Office Action Summary	Application No. 10/585,047	Applicant(s) LUTZ ET AL.	
	Examiner JOHN K. KIM	Art Unit 2834

DETAILED ACTION

3. Applicant's amendment necessitated the new ground(s) of rejection presented in this Office action. As a result, applicant's arguments have been considered but are moot in view of the new ground(s) of rejection.
4. The examiner's supplementary responses to the arguments are herewith presented respectfully.
5. Drawing Objections
 - The point P and tangent T

Fig. 5

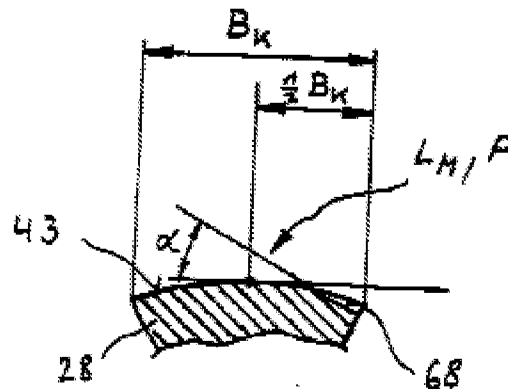
Claim 1 refers "defines a point (P), and a tangent (T) can be inscribed into this point (P)" but shown in Fig. 5 is a line instead of a point and designated to (L_M , P or $L_{M1}P$ as not clear to read due to hand-written). Thus, no P and T are shown. It is recommended to amend the drawing to clear which it is pointing to.

Claim 1 refers “defines a point (P), and a tangent (T) can be inscribed into this point (P)” but shown in Fig. 5 is a line instead of a point and designated to (L_M, P or L_{M1}P as not clear to read due to hand-written). Thus, no P and therefore T are shown.

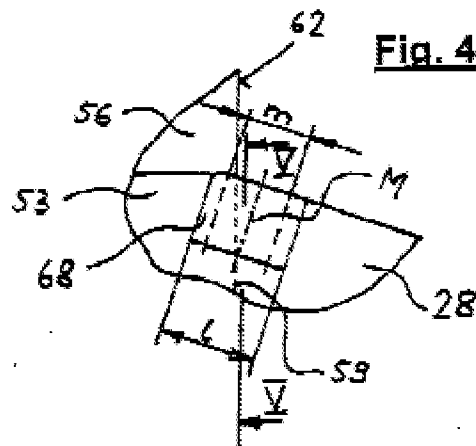
The question was where the 'm' starts. "M" is a center line of the cut out. As best understood from the answer, any point on the cut out can be a start of 'm'. Any point can satisfy (1) the center portion m is arranged symmetrically to the center M and (2) this means that the remaining longitudinal sections on both sides of the center portion m are the same size. The specification (page 9, line 1-12) and claims 1 and 3 define the center portion m where the transition plane 59 intersects, but there is no clear definition where m is starting. Furthermore, Fig. 4 shows the m starts inside the intersection point

of transition plane (59). In claim 1, therefore, major two condition determining the 'm'; one is that the center portion 'm' where the transition plane 59 intersects, and the other is that the center portion 'm' amounts to 8/10 of the length. However, at least shown in Fig. 4 is not correct. Thus, the argument is not persuasive.

Claims 1 and 3 refer “wherein the chamfer (68) has a center portion m in an edge direction that intersects a transition plane (59) which demarcates the pole root (53) and the freely projecting part of the claw pole (28, 29), and the center portion m amounts to 8/10 of the length, oriented in the edge direction, ...” but there is no clear definition where m is starting. Furthermore, Fig. 4 shows the m starts inside the intersection point of transition plane (59). See response to argument above.

Sketch from Fig. 7 (alpha is 22 degrees)

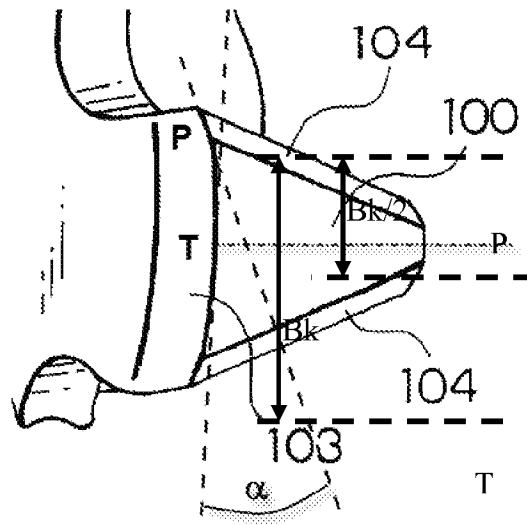
From Fig. 7 of Asso, an angle of inclination α , the angle between the tangent T and the chamfer 104, which has a magnitude of between 15° and 25° as the angle 22° degrees is measured by protractor as shown in sketch of Fig. 7 below.

sketch from Fig. 2

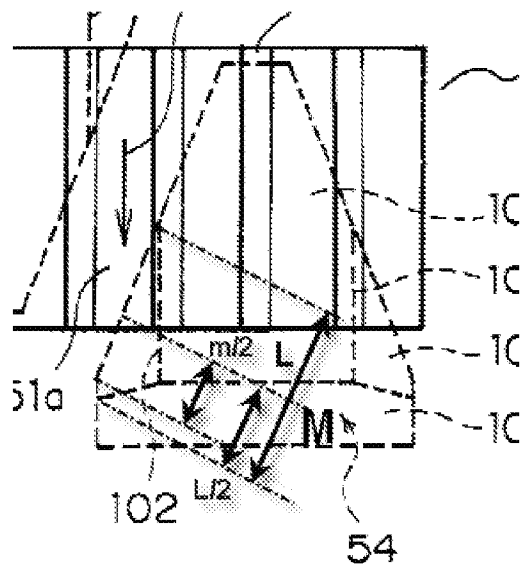
As for claim 1, Asao shows (in Figs. 1-3 and 13) and discloses a claw-pole rotor for an electrical machine, having two pole wheels (51, 52), which each carry claw poles (53 and 54, respectively), which each originate in a plate region (left front plate in Figs. 6 and 7) and have a pole root (103), and on a circumference of the claw-pole rotor (circumference along 103 and 100 boundary), claw poles (53, 54) of the pole wheels (51, 52) are located in alternation, and located between claw poles interstices (between numeric 53B and 100 in Fig. 6), and a claw pole (53, 54) has a radially outward-oriented cylindrical-jacket like surface (100), by which a pivot axis (axis of 6) is defined, and a chamfer (101) extends on the one hand in a circumferential direction and on the other in an edge direction of a claw pole (53 and 54, respectively), wherein the chamfer (101) has a center portion m in an edge direction that intersects a transition plane (103 and 100 border plane) which demarcates the pole root (103) and the freely projecting part of the claw pole (100), and the center portion m amounts to 8/10 of the length, oriented in the edge direction, of the chamfer (101) (see sketch below); and wherein the claw pole (53, 54) has a width (Bk) oriented in the circumferential direction, and a half width (Bk) on the cylindrical surface (100), in a plane of the claw pole (53, 54) that is

vertical to the pivot axis (axis of shaft 6), defines a point (P), and a tangent (T) can be inscribed into said this point (P) (see sketch below). In above disclosures, Asso is silent to show or disclose an angle of inclination α which has a magnitude of between 15° and 25° is enclosed between the tangent (T) and the chamfer (101) in the plane that is vertical to the said pivot axis. However, Asso further shows (in Fig. 7) an angle of inclination α which has a magnitude of between 15° and 25° (22 degrees measured by protractor for the angle in sketch of Fig. 7 below) is enclosed between the tangent (T) and the chamfer (101) in the plane that is vertical to the said pivot axis. Therefore, it would have been obvious to a person of ordinary skill in the art at the time the invention was made to combine the teachings for chamfer angle since it has been held that discovering an optimum value of a result effective variable involves only routine skill in the art. *In re Boesch*, 617 F.2d 272, 205 USPQ 215 (CCPA 1980).

As for claim 3, Asao shows and discloses the claimed invention as applied to claim 1 above. Asao further teaches (in Fig. 2) the chamfer (101) has a center (M) in the edge direction (see sketch above) that is located close to the transition plane (103 and 100 border plane) from the pole root (103) to the freely projecting part of the claw pole (100).

FIG. 3

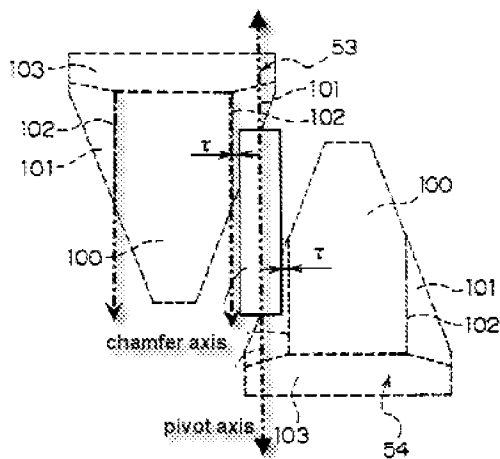
As for claim 8, Asao shows and discloses the claimed invention as applied to claim 1 above. Asao further teaches (in Figs. 1-3) the chamfer (101) is a plane which is oriented parallel to the pivot axis direction (axis of shaft 6). (see sketch below)
